March 8, 2024

Re: Farm Road Homes 40B – Preliminary BoH Questions and Comments Regarding Septic Effluent Impact Analyses
(per CLAWE 2-2-2024 update)

Creative Land & Water Engineering, LLC (CLAWE) has received and reviewed the comment from Sherborn BoH dated February 15, 2024. This letter provides our responses. To facilitate the review, we will quote the Reviewer's comments first in *italics* and follow-up with our response in *red*.

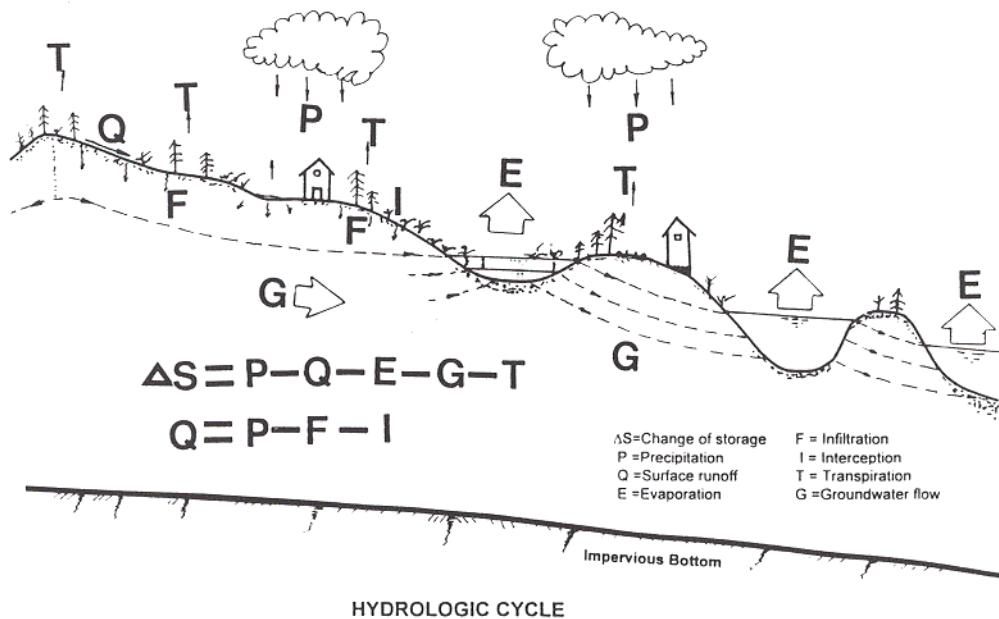
M. How has the **water budget for the site been determined?**

Response: Water budget is a hydrology analysis illustrated in the following diagram. In a simple word, the water budget we are trying to calculate for the concern of nitrogen loading is the long term groundwater recharge volume, as G in the diagram. We attached the detailed description to this letter for our calculations. Please note, DEP is in the process updating their stormwater management regulations requiring more groundwater recharge, which is more in line with our analysis in the past 30 years that we always provided more groundwater recharge than currently required by DEP based on our more detailed hydrology analysis.
